**Amendments to the Drawings:**

## **REMARKS**

This amendment is submitted in response to the Office Action mailed April 8, 2005. Claims 1-6, 8-15, 17-18 and 20 remain in this application. Claims 7 and 16 are cancelled by this amendment. Claim 19 is cancelled in this response as a result of a restriction requirement.

FIG. 3

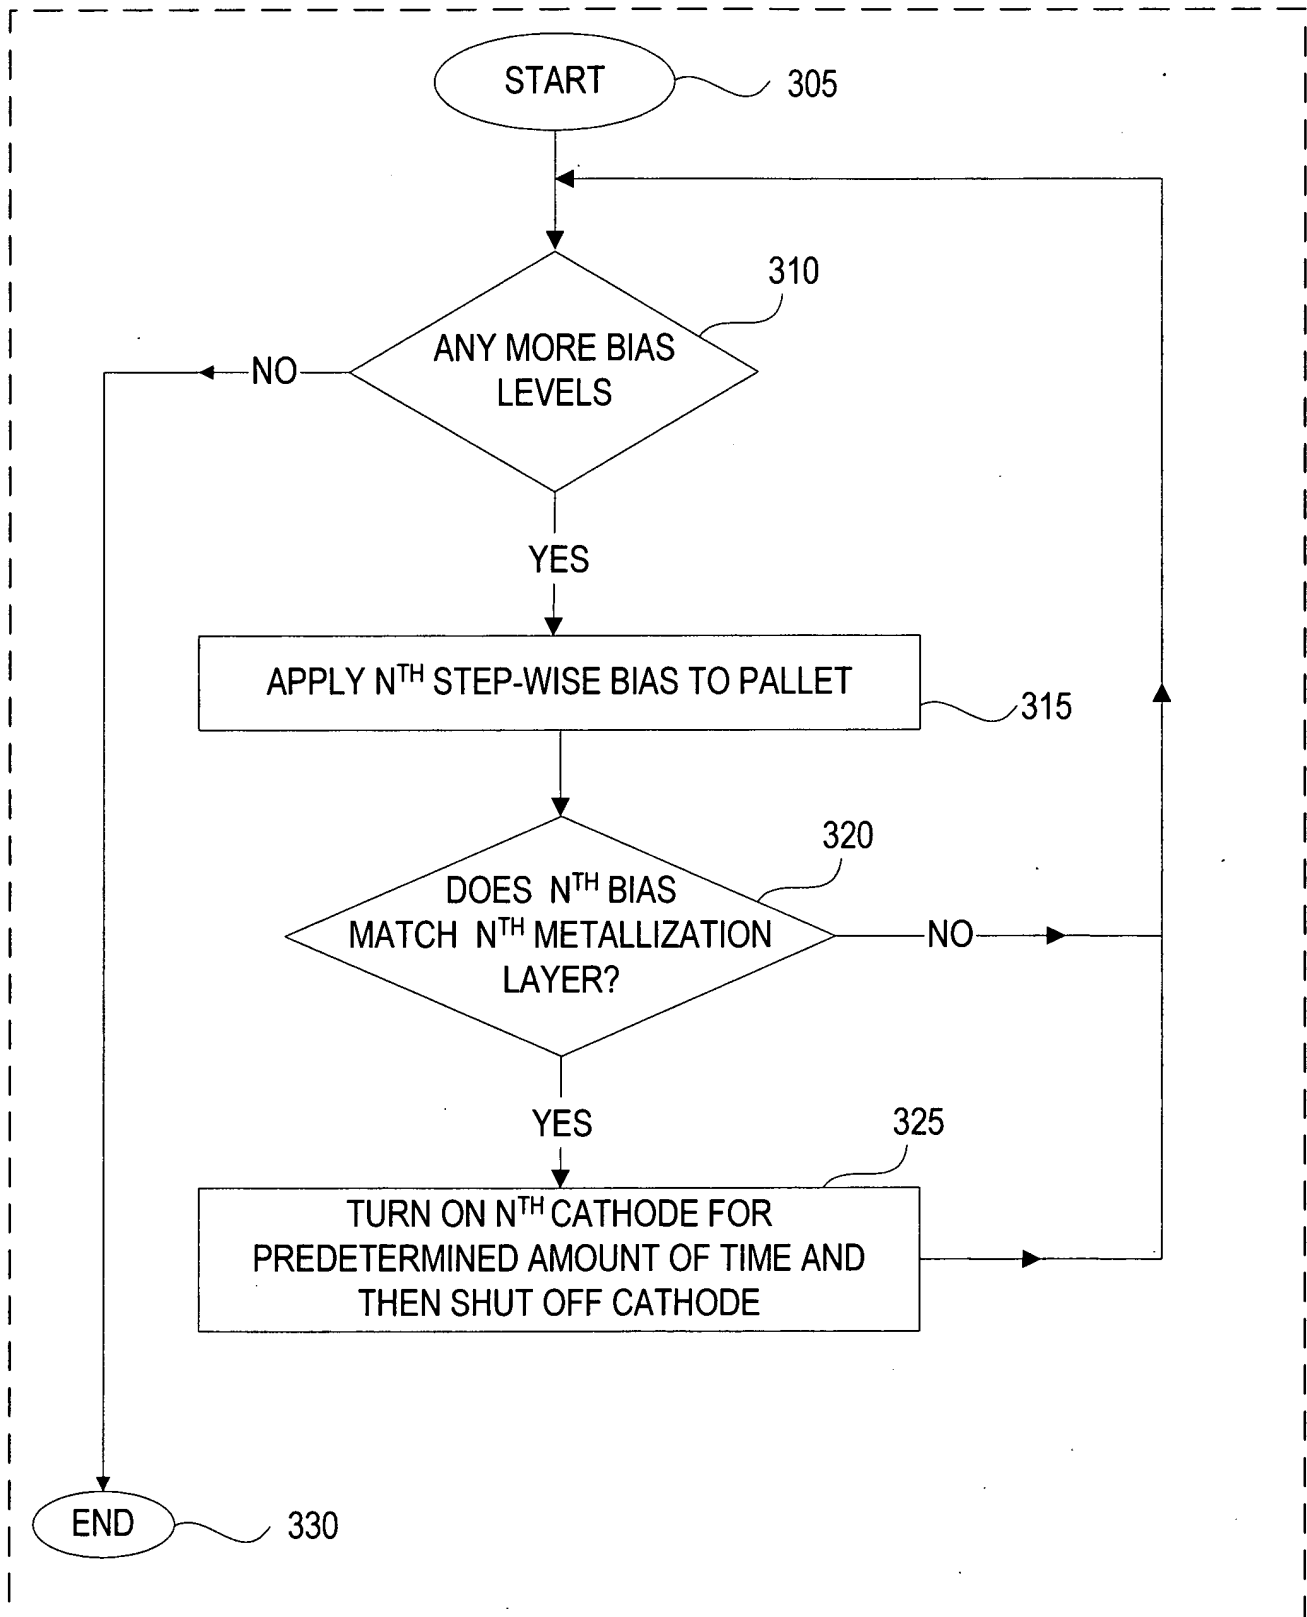
The attached sheet of drawings includes changes to Fig. 3. This sheet, which includes Fig. 3, replaces the original sheet including Fig. 3. In Fig. 3, wrongly numbered elements have been renumbered as 305, 310, 315, 320, 325, and 330.

In the Office Action the Examiner objected to the drawings as failing to comply with 37 CFR 1.84(p)(5) because they do not include the following reference sign(s) mentioned in the description: 170 [0008]; 305, 310, 315, 320, 325, and 330 [0031]; and 430 [0035]. The Applicant has amended paragraph [0008] to eliminate 170, amended

figure 3 to include the proper reference signs 305, 310, 315, 320, 325, 330, and amended paragraph [0035] to correct the reference to 430.
